# Development Review Committee

## Staff Report

<b>Case No:</b>	16DEVPLAN1006
<b>Request:</b>	Community Facility Review
<b>Project Name:</b>	Clifton Heights CSO Storage Basin
<b>Location:</b>	1827 Drescher Bridge Ave.
<b>Owner:</b>	Louisville/Jefferson County Metro Government
<b>Applicant:</b>	Meskerem Eshetu - MSD
<b>Representative:</b>	Meskerem Eshetu - MSD
<b>Jurisdiction:</b>	Louisville Metro
<b>Council District:</b>	9 – Bill Hollander
<b>Case Manager:</b>	Ross Allen, Planner I

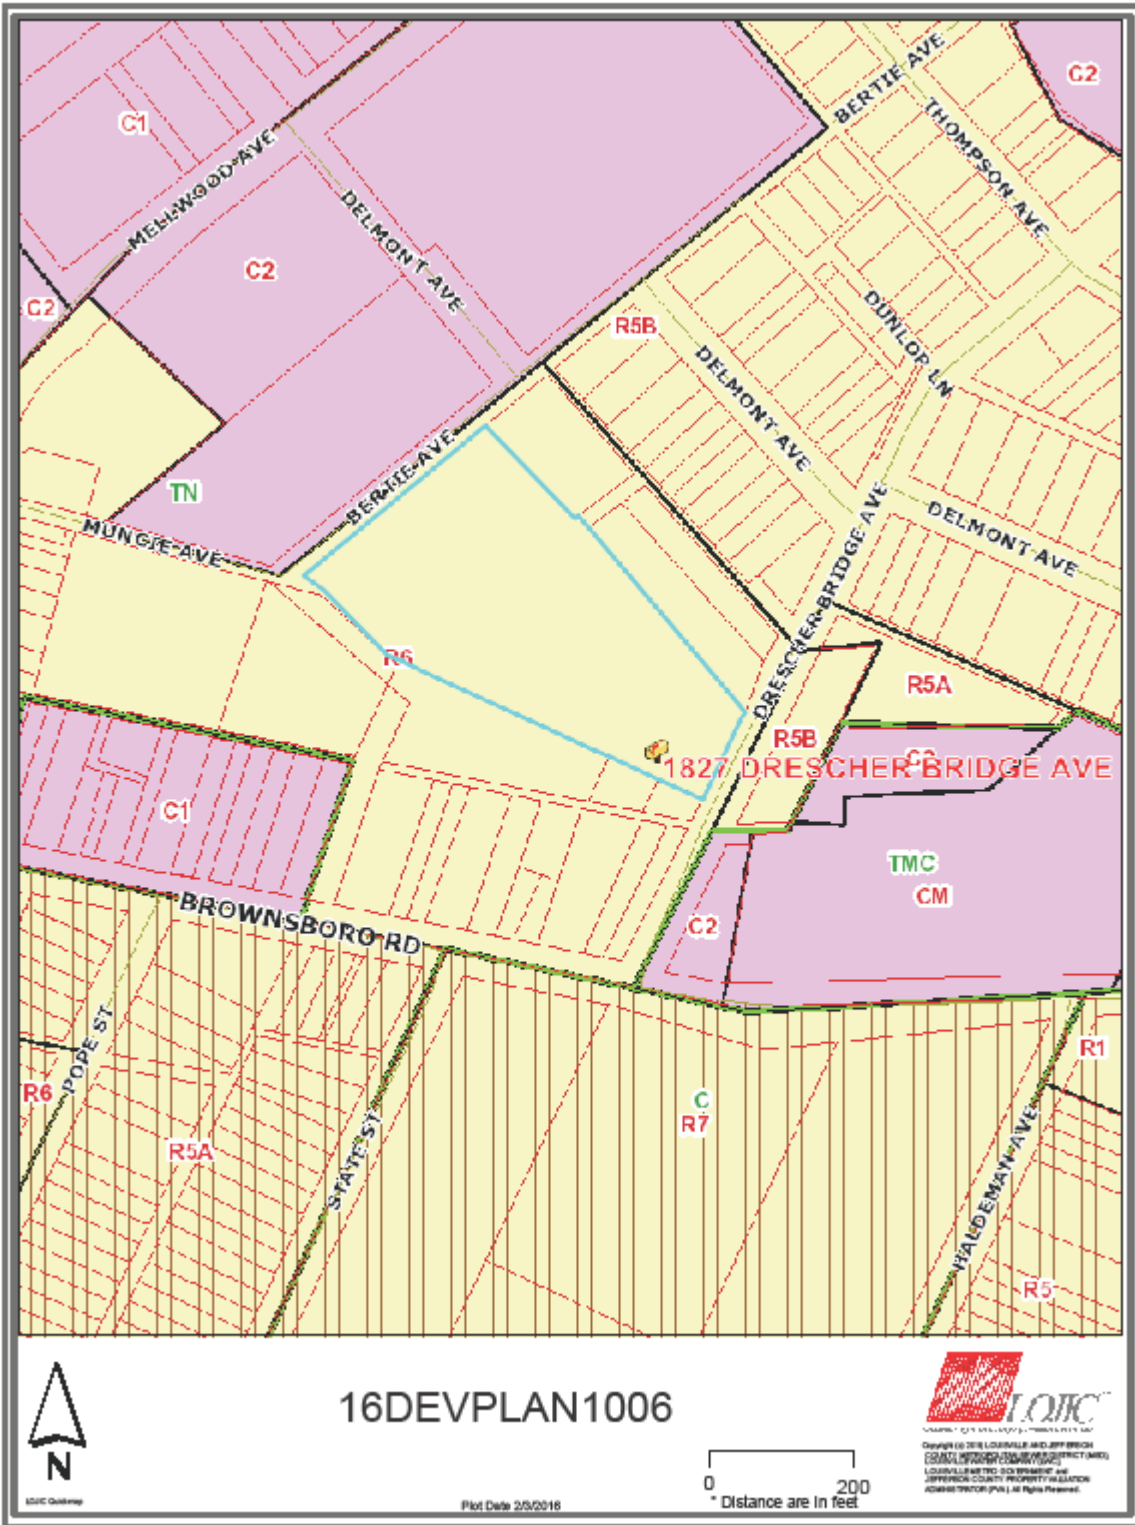
1. The applicant should explain how the non-residential expansion into a residential area could potentially impact residences in the general vicinity (see aerial map page 5).
